SUBJECT: GRAND GULF NUCLEAR STATION, UNIT 1 - STAFF ASSESSMENT OF  
FLOODING FOCUSED EVALUATION (CAC NO. MF9897; EPID  
L-2017-JLD-0015)

STAFF ASSESSMENT BY THE OFFICE OF NUCLEAR REACTOR REGULATION

GRAND GULF NUCLEAR STATION, UNIT 1

**Attachment – Staff Assessment of Grand Gulf Nuclear Station, Unit 1  
Revised Local Intense Precipitation Model**

Figure A1-1. Site Map with FLO-2D Model Layout

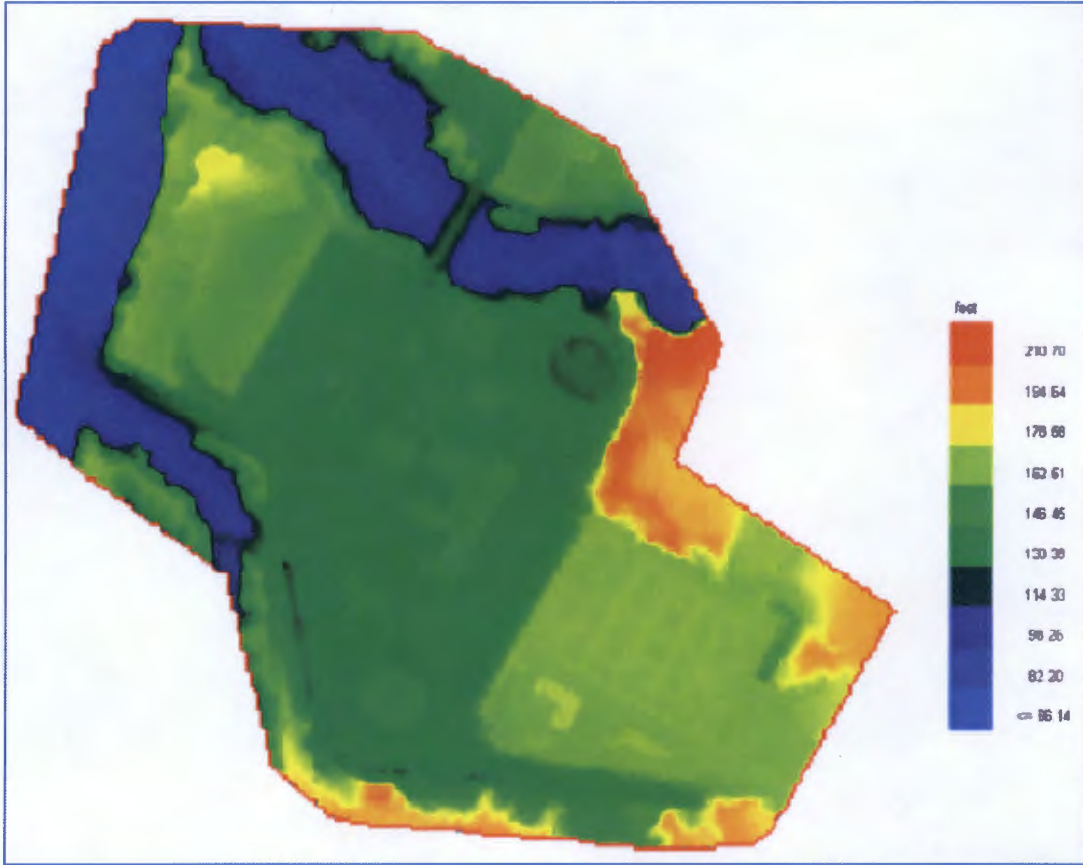
Figures A1-1 and A1-2 show the model grid and inundation flood map results using the revised FLO-2D model. The licensee verified the water budget calculation for the simulations as discussed in their calculation. The licensee reported in its FE report that the total model inflow (rainfall) is equal to the sum of outflow and storage components, indicating nearly zero water budget errors. The staff confirmed the water budget equality between the simulated inflow and outflow components, and also confirmed there were no numerical stability issues. Therefore, the staff determined that the revised FLO-2D model and simulation results are acceptable for use in the FE.

Figure A1-3a. Location of point of interests for LIP flood analysis

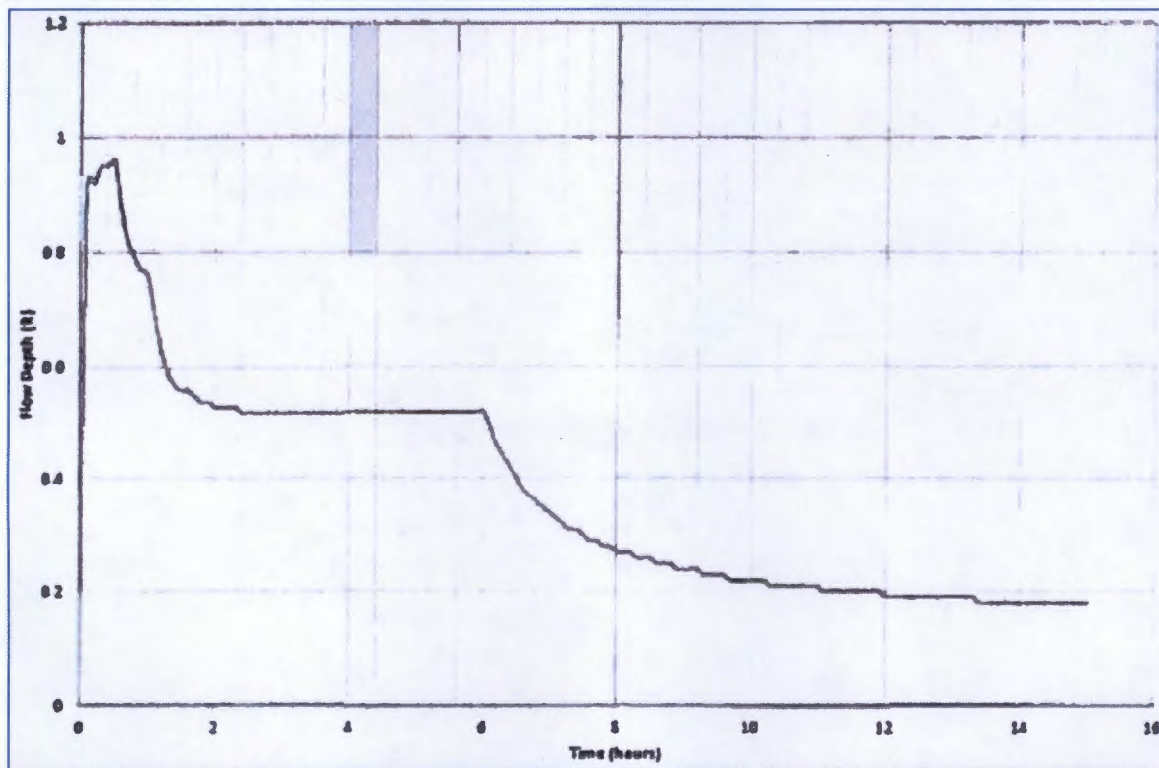
The licensee stated in its FE that they checked the high-tail elevations in hydrographs for the representative FLO-2D grid cells assigned to the doors of interest (Figure A1-3) and compared them with the topography map. In addition, the licensee investigated time-series output of flood parameters (i.e., maximum flow depth, maximum water surface elevation) by rechecking the output results with the revised FLO-2D (Entergy, 2017). They noted in the FE report the following two items:

Figure A1-4 Example stage hydrographs for Door 2M111 (top) and Door OCT5 (below)

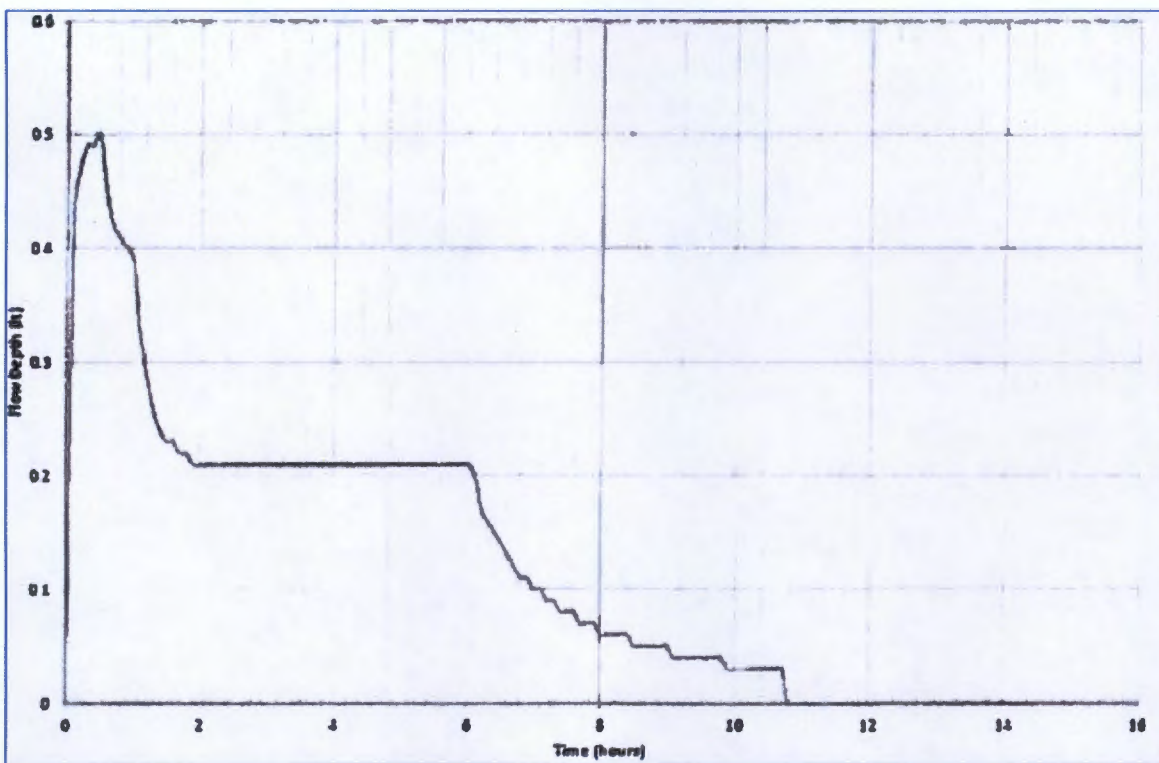
- The licensee noticed zero inundation depth after approximately 11 hours of simulation time at the Door 2M110 (Grid Cell No. 19579 with elevation 133.09 ft. MSL) (Figure A1-4, top). The licensee found that this grid cell has considerably higher elevation compared to nearby grid cells. Therefore, ponding for a long time with a relatively constant flow depth is not expected, justifying the full drain (flow depth down to zero) shown in the stage hydrograph.

- At the Door 0CT5 (Grid Cell No. 25481 with elevation 132.67 ft. MSL) location, the licensee noted approximately 0.2 ft. inundation depth at the tail of the hydrograph (see Figure A1-4, bottom). The licensee stated in its FE that this grid cell and other close-by cells are flat and have relatively lower elevations compared to the outer surrounding cells, justifying the prolonged inundation pattern at this location. They found the same inundation pattern at door locations 1D312, 1D310, and 2M111.

Therefore, the licensee concluded that the long-tails in the hydrographs are realistic and consistent with the topography and ground elevations surrounding these doors. Based on an independent review of the hydrographs generated from the revised FLO-2D output files, the staff determined the hydrographs simulated by the revised FLO-2D are reasonable. Table A1-1 summarizes the revised LIP flood elevations as well as flood depths at key monitoring locations.
